State of New Mexico
Energy, Minerals and Natural Resources

WELL API NO. 30-015-22718
5. Indicate Type of Lease STATE ☐ FEE ☒
6. State Oil & Gas Lease No.
7. Lease Name or Unit Agreement Name BIG CHIEF COM
8. Well Number 002
9. OGRID Number 228937
10. Pool name or Wildcat DUBLIN RANCH; ATOKA (GAS)

Matador is requesting to plug and abandon the Big Chief Com #002 per the required COA, following the procedure below:

Big Chief Com #002
660' FSL & 1980' FWL Sec. 22-22S-28E
Eddy County, NM
API: 30-015-22718
CURRENT WELLBORE SCHEMATIC
Spud: 10/21/1978

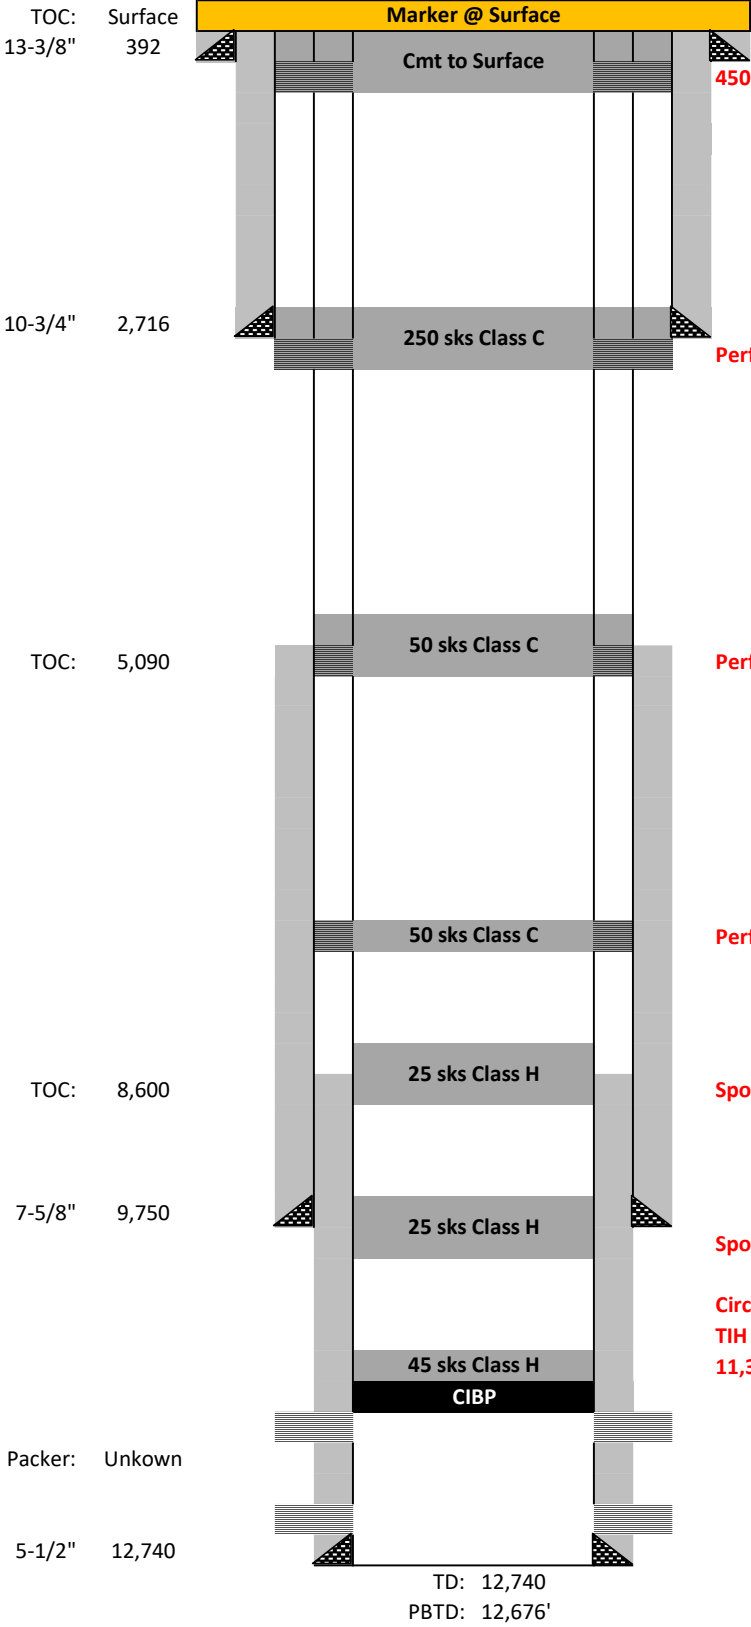
450': Perf & Sqz Class C cmt to surface on all strings (Est. ~200 sks) (Top of Salt / Surface Shoe)

Perf & Squeeze 250 sks Class C cmt at 2,770' (Est. 2,170' / Req. 2,310') (Intermediate Shoe, Delaware, & Base of Salt); WOC & Tag

Perf & Squeeze 50 sks Class C cmt at 5,140' (Est. 4,833' / Req. 5,040') (Intermediate TOC); WOC & Tag

Perf & Squeeze 50 sks Class C cmt at 7,480' (Est. 7,173' / Req. 7,380') (Bone Spring); WOC & Tag

Spot a 25 sk Class H cmt Balanced Plug at 8,650' (Top of Cement - adjust per CBL)

Spot a 25 sk Class H cmt Balanced Plug at 9,800' (Intermediate Shoe & Wolfcamp)

Circulate wellbore full of MLF
TIH & Spot 45 sks Class H cmt on CIBP (Est. 11,018' / Req. 11,120') (Open Perforations, Atoka, & Strawn); WOC & Tag
11,385': RIH & Set CIBP; Test casing to 500 psi for 30 minutes & Bubble test; Run CBL to surface.

- Notify NMOCD 24 hrs before MIRU.
- Safety mtg, MIRU, check pressures, ND wellhead, NU & test BOPs, POOH w/ tubing.
- **Set CIBP @ 12110' - Test CIBP 500psi/30min - DB 4 sx cl H cmt or pump 15 sx - T Morrow - WOC & Tag**
